Manual Update Notice

Manual title: NXT Programming Manual
Manual number (updated edition): QD004-05
Manual number (previous edition): QD004-04
Date of issue: September 19, 2005

In accordance with NXT version V3.41, changes have made as follows.

Vision Type 181 Coil parts with two leads at 45 degree angles

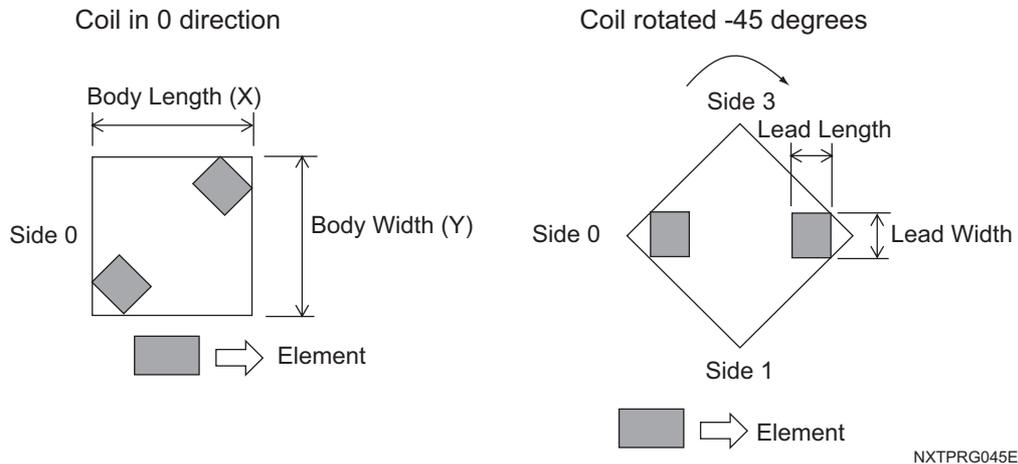
Chapter, Section	Summary of changes
4.3.2 Shape Process Tab	New data item has been added.
4.3 4 Shape Process Details	Detailed explanation has been added.
4.6.2 NXT Vision Types	Added vision type 181 to table and detailed explanation section.
4.7.2 Vision type compatibility table for the NXT	Added vision type 181. Changed table font size.
6. Editing Jobs on the Machine	Added new section "6.6 Testing Pickup Positions".
	Minor changes and corrections have also been made at various locations throughout manual.

Use this vision type for coil parts with 2 leads that are at 45 degree angles from the x-axis (as shown below). The body color is black and only the leads are visible during vision processing. Enter the body size and element information in part data based on the information below.
